Modification Recommended Service Note

Supersedes:
N4693D-02

N4693D Electronic Calibration Module (ECal)

Serial Numbers: MY57450000- MY59410001

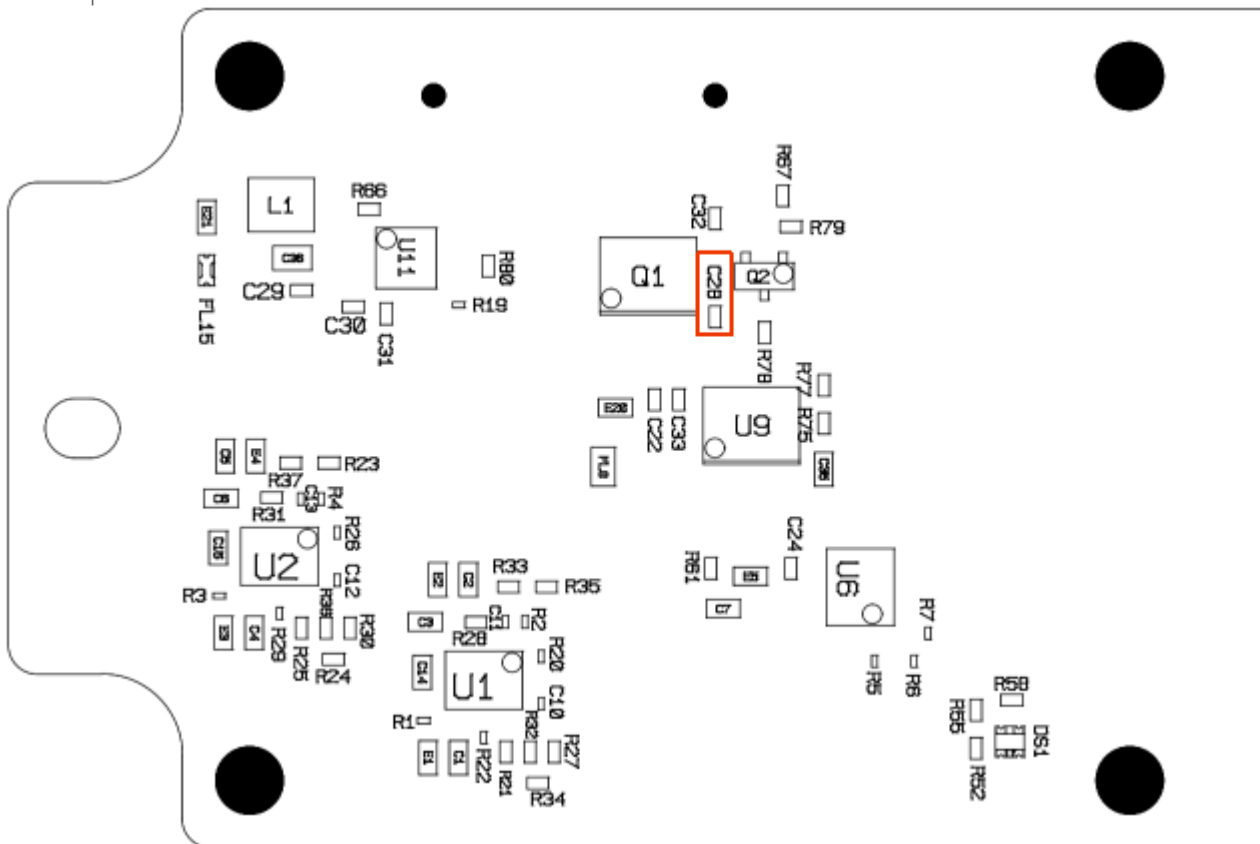
The heater circuit in the N469xD ECal modules was initially designed with a dampening capacitor. It was found in a small number of ECal modules that a resonance can develop in this circuit after the modules is warmed up. This resonance can cause an RF tone between 140 MHz and 150 MHz to be injected onto the signal path.

Open the ECal module and remove the N4690-63004 printed circuit board. On this board, locate the C28 capacitor indicated here:

If this capacitor has been removed, no further action is required. Reassemble the ECal module.

If this capacitor exists on this board, this capacitor should be carefully unsoldered and removed, or the N4690-63004 printed circuit assembly should be replaced. Once this is done, reassemble the ECal module.
